# Application for change or cancellation of resource consent condition (S.127)

Application for consent condition variation s127 – RC 2240110, 34A Gillies Road, Karikari Peninsula

Please find below a s127 application in relation to a proposed variation of consent conditions associated with RC 2240110.

In relation to the above, the applicant seeks to include an artistic mural across the approved shed as opposed to the Ironsand colour approved under the decision.

Figure 1 - Proposed Mural

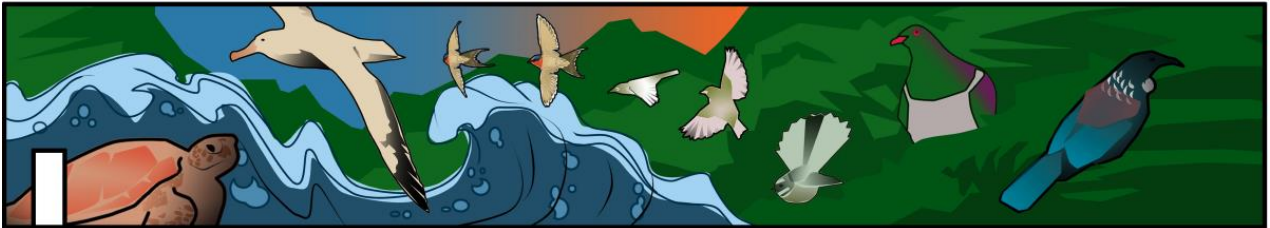
The mural doesn't strictly fit within the typical 30% LRV framework, due to some of the lighter colours proposed that are used to paint some of the animals.

The proposed mural is designed to integrate with the natural environment, utilizing a colour palette and subject matter that reflect the local landscape and fauna. The mural predominantly uses greens and blues. The greens are intended to match the detailed vegetation of local plant species. The blues, representing the sky and water, are darker with minimal lighter tones avoiding harsh, unnatural colours. The orange of the sky is also depicted in a muted tone to represent a natural evening or

The mural features native New Zealand bird species, including the Albatross, Swallow, Waxeye, Fantail, Kererū, and Tūi alongside a turtle. The vegetation will also be painted from local plant species, as indicated by the photo references of the surrounding bush. This focus on local flora and fauna allows the artwork to tell a story about the specific location, celebrating the natural character of the Far North coastal environment rather than detracting from it.

(c) Joel Nicholls, referenced Mural Concept, dated 16 July 2025.

The exterior of all new buildings shall have a reflectivity value (RV) in exterior finishings as described in the landscape report by Hawthorn dated 20 July 2023, except for the shed to be painted with the Mural Concept approved in Condition 1.

Figure 4 – Photo of Site / Neighbours Site

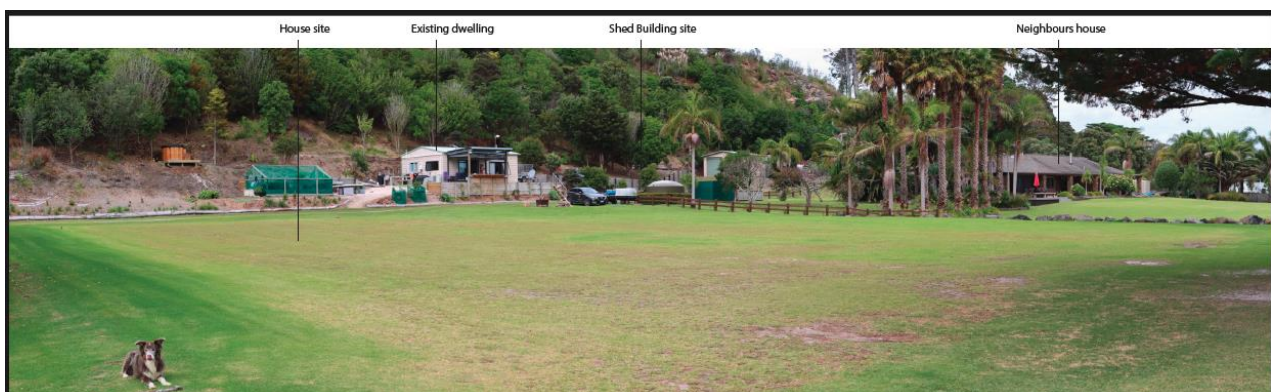
Turning to potentially affected persons, the owners of 34 Gillies Road have been assessed in more detail due to the location of their site in relation to the proposal.

It is noted that their site gains access from a shared right of way further to the south of the application site. Their site is well landscaped and naturally appears to be oriented towards the CMA, as opposed to having views to the east back at the shed / mural.

The key mitigation measure in this respect is the landscaping promoted in front of the retaining wall with heights of the species selected – Pslp reaching up to 3-4m in height, and Scac reaching heights of up to 8-10m which are not proposed to be changed though the proposal. These will soften views but will not completely remove them.
